Certificate of Appropriateness

1927 & 1927A N. 2ND ST. Brewer's Hill Historic District

PTS ID 114365 COA: replace block window, enclose former balcony door

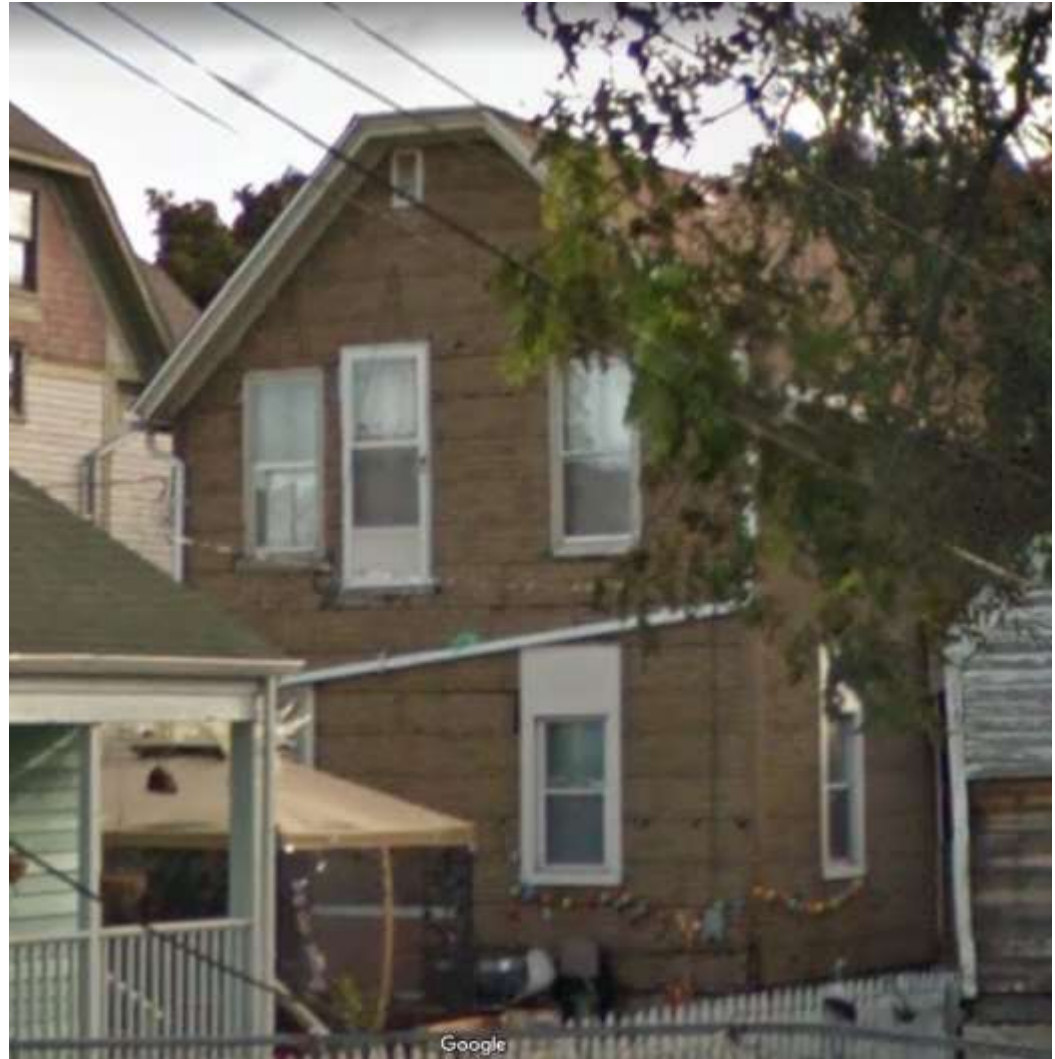
Restore single pane window at
far left. Vinyl window and glass
block window have previously
been required to be removed.

Remove second floor “door to nowhere” and patch area with smooth wood clapboards or asphalt siding to match existing.
